Technical Specification Group Services and System Aspects
Meeting #23, Phoenix, Arizona (USA)
15-18 March 2004

TSGS#23(04)0078

Title: CR 26.073 019 Correction of AMR DTX functionality (Release 5)

Figure 2 Decoder output with with the original v 5.2.0 encoder

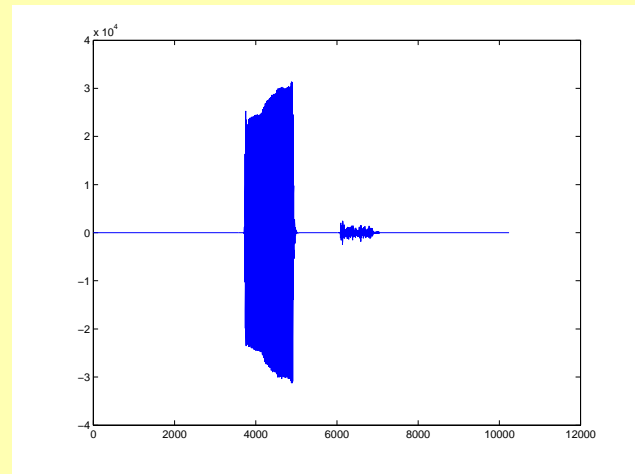
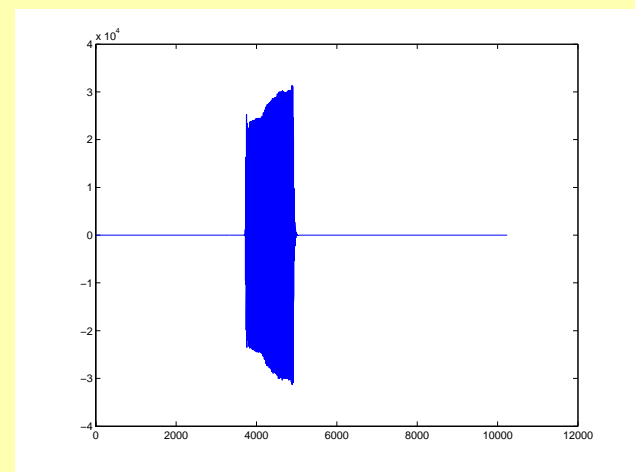
Reason for change:	# AMR codec can produce annoying output during DTX-operation.
Summary of change:	# The current AMR DTX logic overrides the DTX hangover period when the average energy of the silence or background noise before the short active tone is close to zero. The proposed correction removes this overriding. With certain short tones, the current DTX logic may produce SID frames right after the VAD algorithm has detected silence without DTX hangover period. In this case, the SID parameters (avaraged LPC and signal gain) are calculated during the tone (active signal, speech). Therefore, the comfort noise representation does not represent the true background noise or silence. The problem occurs with short tones when the signal energy is close to zero between the tones. In addition, the tone length needs to be shorter than the DTX_ELAPSED_FRAMES_THRESH, i.e. 30 frames.
Consequences if not approved:	# AMR codec output can produce annoying output with certaing signals when DTX is used.

<input type="checkbox"/>	<input checked="" type="checkbox"/>				
	<table border="1" style="display: inline-table; border-collapse: collapse;"> <tr> <td style="text-align: center;"><input type="checkbox"/></td> <td style="text-align: center;"><input checked="" type="checkbox"/></td> </tr> </table> O&M Specifications	<input type="checkbox"/>	<input checked="" type="checkbox"/>		
<input type="checkbox"/>	<input checked="" type="checkbox"/>				
Other comments:	# Example of DTX functionality. Input signal is processed with AMR encoder using mode 12.2 with DTX on. Following figures shows decoder v 5.2.0 output using the original v 5.2.0 encoder and the new encoder having corrected DTX functionality. Similar performance is achieved with all AMR modes.

```
/* VOX mode computation of SID parameters */
test (); test ();
if ((computeSidFlag != 0))
{
```
